Ordinance: ORD-0033-2022

AN ORDINANCE TO ACCEPT THE FINAL PLAT FOR THE CRESCENT AT CENTRAL PARK SECTION 2; CONSISTING OF FOUR LOTS AND RESERVES "B" AND "C" LOCATED ON BUCKLES COURT NORTH; PARCEL ID NO. 025-013773; CURRENT ZONING SELECT COMMERCIAL PLANNED DISTRICT (SCPD); LARRY CANINI, APPLICANT; WAIVING SECOND READING AND DECLARING AN EMERGENCY

Subject: Crescent at Central Park Section 2 Final Plat
City of Gahanna, Franklin County, Ohio
CEC Project 314-902

RE: Project Buckles Court North Final Plat

PLAT

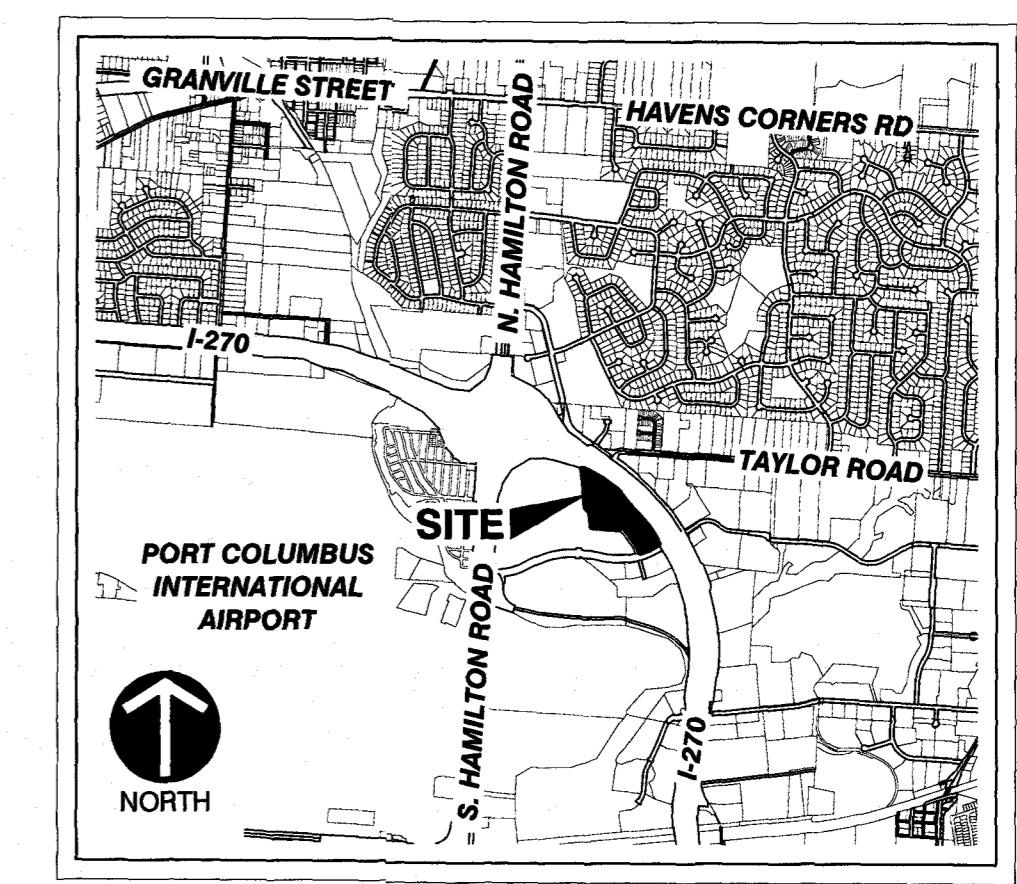
1. Note B on the plat states that reserves A and B will be owned by the City. Reserve A doesn't appear to be land included in this plat. Reserve A was included in the 2018 final plat and was to be owned by the property owner and maintained as open space. The City has discussed, and we are not interested in ownership of the reserve areas. Please revise accordingly.

6. Please correct the "Floodplain Designation" note to indicate that only Flood Zone X is located on this subdivision, rather than "Flood Zones: Zone "X" and "X"".

9. Add a Note "D" to the Plat to the effect of "In accordance with Gahanna Codified Ordinance 1193.05, The lands within the Crescent at Central Park Section 2 have been granted a waiver from the stormwater quantity control requirements of Gahanna Codified Ordinance 1193.06(a) and 1193.06(b)."

Note B updated to remove ownership by the City.

The Floodplain designation has been updated.

Note has been added.
